Applicant Outreach Summary

CivicWorks and ATCO are committed to being good neighbours and working with the Arbour Lake community throughout this Land Use Redesignation and Development Permit application process. In support of the applications for this project, CivicWorks undertook a proactive outreach program to ensure a clear process for interested parties and groups. Various outreach strategies were implemented between August and September 2024 and are further detailed below. Interested parties including the Arbour Lake Community Association, Arbour Lake Residents Association, and the Ward 2 Office were offered digital meetings and were invited to participate in our process, which focused on informative and fact-based engagement and communications. CivicWorks shared information and offered opportunities for engagement to community residents through custom on-site signage, hand-delivered tri-fold mailers to ±387 residences, and a dedicated project website that included project information, project materials for download, and a feedback form that is monitored by the project team with prompt responses to questions and feedback.

Kasian Architecture was also retained to undertake a

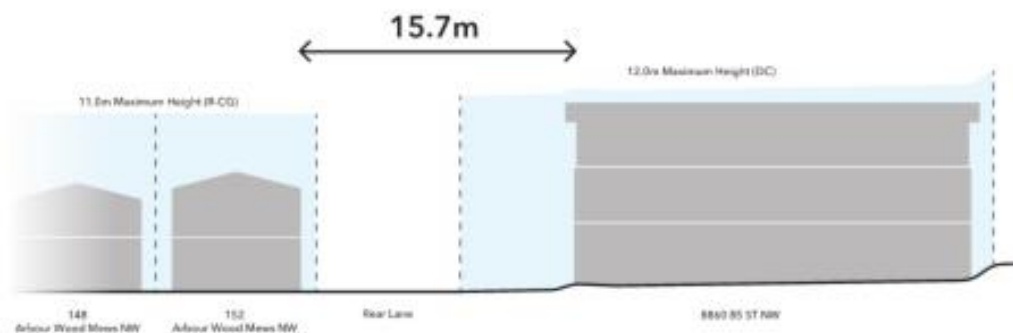
The project team heard concerns from community members regarding the height and architectural style of the proposed development, as well as questions regarding sensitive interfacing with adjacent residential homes.

"The homes are too close together which affects the light entering their homes. Think of mental health issues."

The existing S-CRI District has no maximum building height for the subject site. The proposed DC District, based on the M-CG District, and the concurrent Development Permit (DP2024-05929), envision 3-storey townhomes with a maximum building height of 12m. The proposed 12m maximum is a modest increase of 1m from the 11m maximum building height of the surrounding R-CG-designated parcels.

Project Architect, Kasian, has taken careful consideration to orient the townhomes and unit entries towards each other and into central courtyards, away from adjacent neighbours. Windows are limited along edges that

The project team explored several iterations of the site plan to best utilize the site and mitigate negative impacts on neighbouring homes, such as overlooking and shadowing. The site plan as proposed in the concurrent Development Permit (DP2024-05929), pushes the townhomes further north on the site, away from the rear lane and existing homes along Arbour Wood Mews NW. Currently, the proposed townhomes are $\pm 15.7\text{m}$ from the residential homes across the paved rear lane.
